Product Change Notice (PCN)

PCN Number: **PCN-0450952R-01**

Product(s) Affected: *PJ-025*

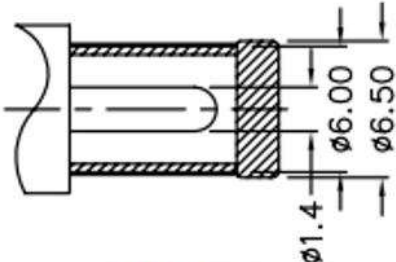
Description of Change: *Minor Housing and footprint differences. Material Change on the housing and terminals. See image Below*

PREVIOUS CUI DEVICES DETAIL / IMAGE			NEW CUI DEVICES DETAIL / IMAGE		
	MATERIAL	PLATING			
center pin	brass	tin	DESCRIPTION	MATERIAL	PLATING/COLOR
terminal 1	brass	tin	terminal 1	bronze t=0.50	silver
terminal 2	copper alloy	tin	terminal 2	bronze t=0.25	silver
terminal 3	brass	tin	terminal 3	brass t=0.40	silver
plastic	PBT		insulator	PA66 (UL94V-0)	black

MATING PLUG
Jack Insertion Depth: 9.0 mm

MATING PLUG
Jack Insertion Depth: 9.1 mm
